REQUEST

Current Zoning: B-1 (neighborhood business)
Proposed Zoning: MUDD-O (mixed use development, optional) with three-year vested rights

Approximately 0.34 acres located at the southwest intersection of Seigle Avenue and Belmont Avenue, north of Harrill Street.

STAFF RECOMMENDATION

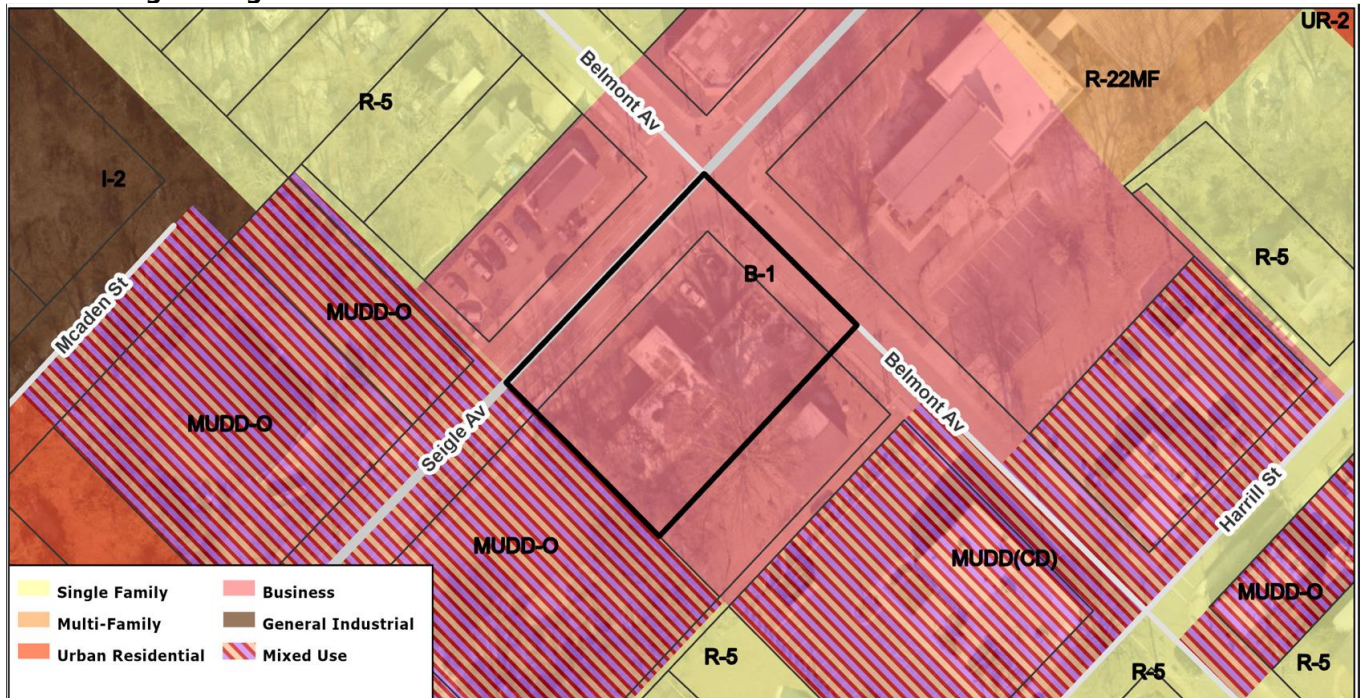
• Proposed Request Details

The site plan accompanying this petition contains the following provisions:

- Construct a 9,000 square foot building having a maximum building height of 50 feet.
- Illustrates parking area, upper and lower retaining wall, public amenity zone (bikes/scooters), public open space/amenitized tree areas, tree save, neighboring specimen trees.

- Provides illustrative sheet with building character/concepts within Belmont community framework.
- **Notes minimum 45 square feet of public open required and minimum 500 square feet proposed.**

- Proposes access via ingress/egress points onto Belmont and Seigle Avenues.
- Allow the following uses: buildings for dramatic, musical or cultural activities; bicycle-sharing station; small-scale class learning business such as culinary school, piano school, yoga/fitness classes and other similar categories; donation drop-off facility; EDEE (Type 1 and 2, subject to [Section 12.546](#)), food stall and/or food establishments including bodega, coffee shop, brewery and restaurant; arcade uses as part of an ice cream/candy shop, or similar indoor small-scale amusement; indoor recreation; institutional uses limited to churches, synagogues, parish houses, Sunday school buildings, convents, community recreation centers, libraries, museums; theaters or art galleries; outdoor fresh produce stands and mobile market produce; outdoor seasonal sales; outdoor open markets, mobile food or retail trucks, pop-up markets; parks, greenways and arboretums; indoor pet services, professional business and general offices; retail sales limited to uses permitted in the B-1 zoning district, services such as beauty/barber shops, locksmiths, studios for artists, designers, photographers, musicians, sculptors, gymnasts, potters, wood and leather craftsmen, glass blowers, weavers, silversmiths and designers of ornamental and precious jewelry, theaters, motion pictures; YMCAs, buildings for social fraternal, social service, union and civic organizations and comparable organizations. **Residential dwelling units (6 maximum), restricted to second and third levels.**
